LONGLEAF GATES SUBDIVISION, PHASE TWO

Engineering Comments: FINAL PLAT COMMENTS (should be addressed prior to submitting the FINAL PLAT for review and/or signature by the City Engineer):

Revised for the December 7th meeting: FINAL PLAT COMMENTS (should be addressed prior to submitting the FINAL PLAT for review and/or signature by the City Engineer):

SITE PLAN

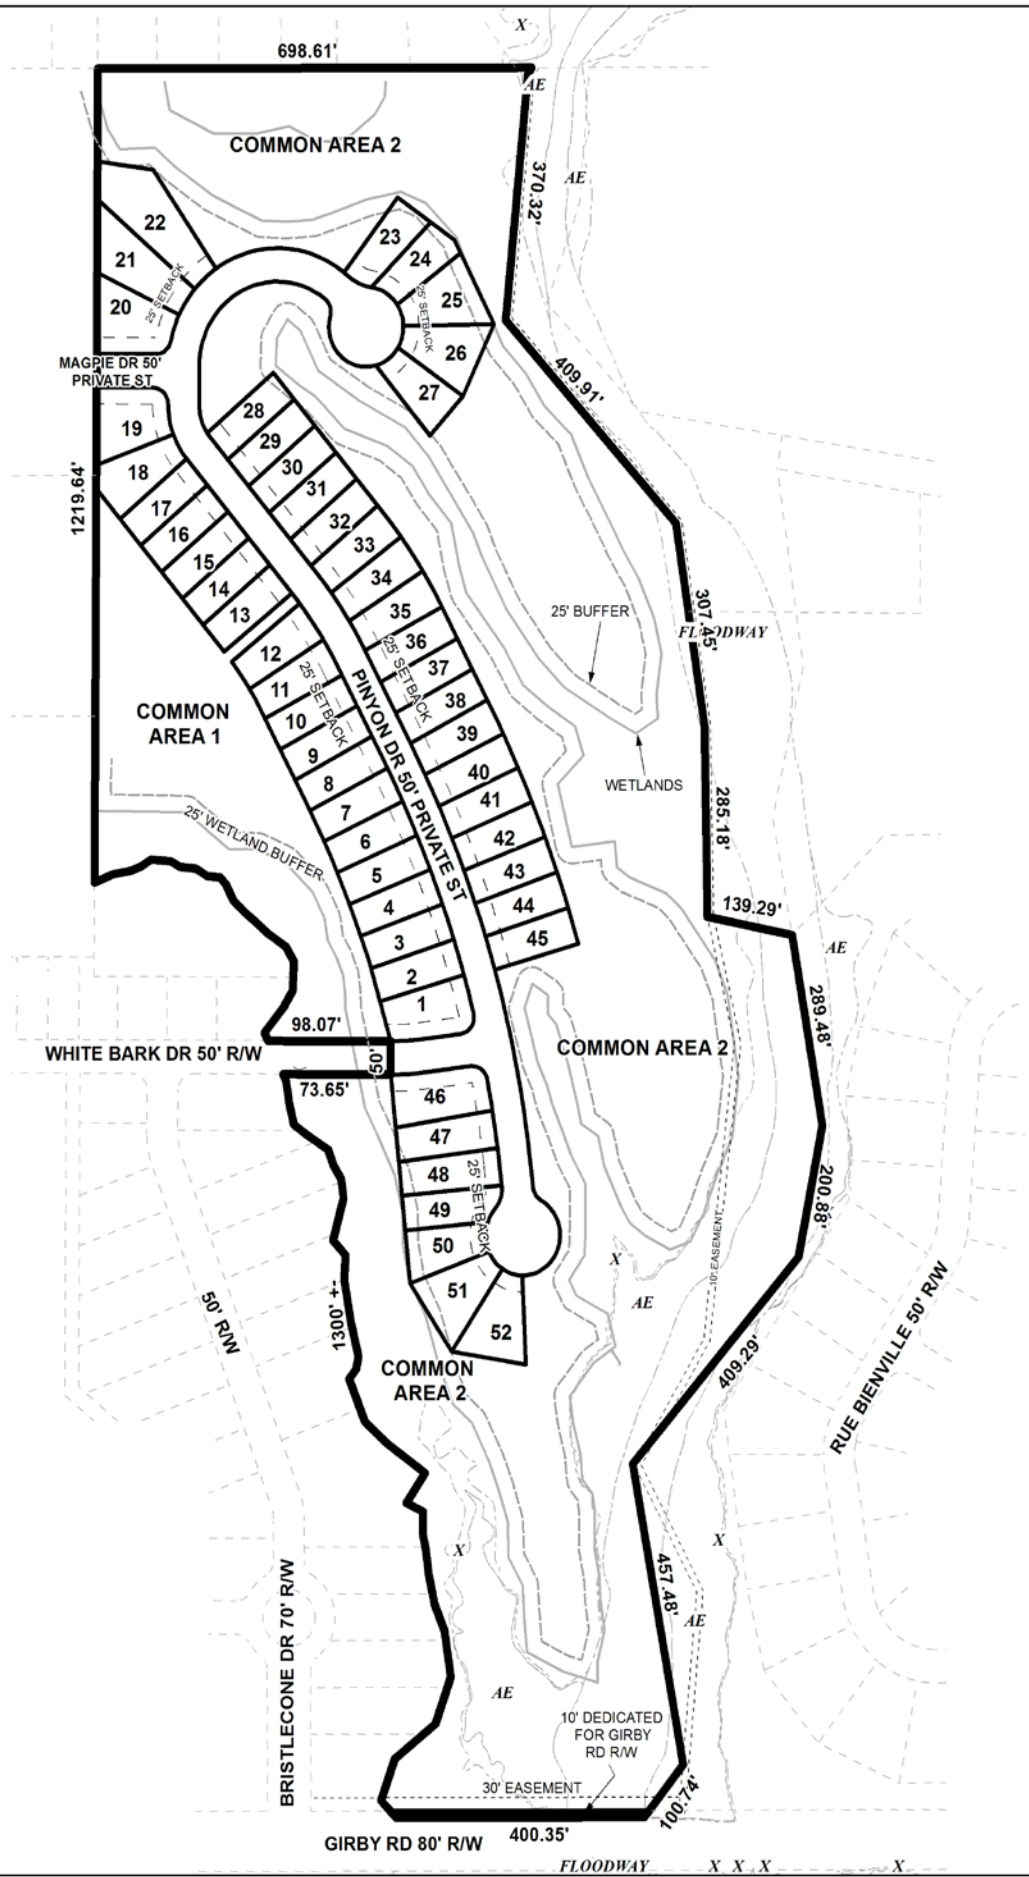
The proposed private street is provided with cul-de-sacs at both terminuses in compliance with Section VIII.E.1.a. of the Subdivision Regulations; however, they do not appear to comply with Section V.B.14. regarding the required 120' turnaround right-of-way diameter. The plat should be revised to illustrate compliant turnaround rights-of-way for both proposed cul-de-sacs, if approved.

The proposed lots meet the minimum size requirements for lots served by public water and sanitary sewer systems; however, while lot sizes are provided in square feet on the preliminary plat, they are not provided in acres. As such, revision of the plat to depict the sizes of each lot in both square feet and acres should be required; or, provision of a table on the Final Plat providing the same information may suffice.

Two common areas are provided on the preliminary plat, to include a detention area between proposed Lots 27 and 28, and are labeled with their sizes in acres. The plat should be revised to also provide their sizes in square feet; or, provision of a table on the Final Plat providing the same information may suffice. A note should also be provided on the Final Plat stating that the maintenance of all common areas, including the detention area, is the responsibility of the property owners.

The 25' minimum building setback line is not illustrated along Girby Road, but it is illustrated along the frontages of all proposed lots and a note on the plat iterates this requirement; however, the line itself is not labeled. As such, revision of the plat to illustrate the 25' minimum building setback line along Girby Road and label the 25' minimum building setback line along the remaining lots should be required, if approved.

Revisions to the preliminary plat illustrate changes in the sizes of proposed Lots 23-27 and 48-52 to accommodate the revised turnaround rights-of-way diameters at the terminuses of the proposed Pinyon Drive, which now comply with the 120' minimum per Section V.B.14. of the Subdivision Regulations.

All proposed lot sizes still meet the minimum requirements for lots served by public water and sanitary sewers, but are still only illustrated in acres. The two proposed common areas are also only illustrated with their sizes in acres. As such, if approved, the plat should be revised to illustrate the sizes of all lots and common areas in both square feet and acres; or, the provision of a table on the Final Plat providing the same information may suffice.

- 1) retention of the additional 10' dedication along Girby Road to provide sufficient right-of-way width;*
- 2) retention of the labels indicating the privacy of the proposed street and street extension on the Final Plat;*

- 3) revision of the plat to label the extension of Magpie Drive as an emergency access only;*
- 4) placement of a note on the Final Plat stating that maintenance of the private street and street stub is the responsibility of the property owners and not the City of Mobile;*

- 6) revision of the plat to depict the sizes of each lot and the common areas in both square feet and acres, or the provision of a table on the Final Plat providing the same information;*

- 8) revision of the plat to illustrate the 25' minimum building setback along all street frontages;*
- 9) placement of a note on the Final Plat denying direct access to Common Area 2 from Girby Road;*
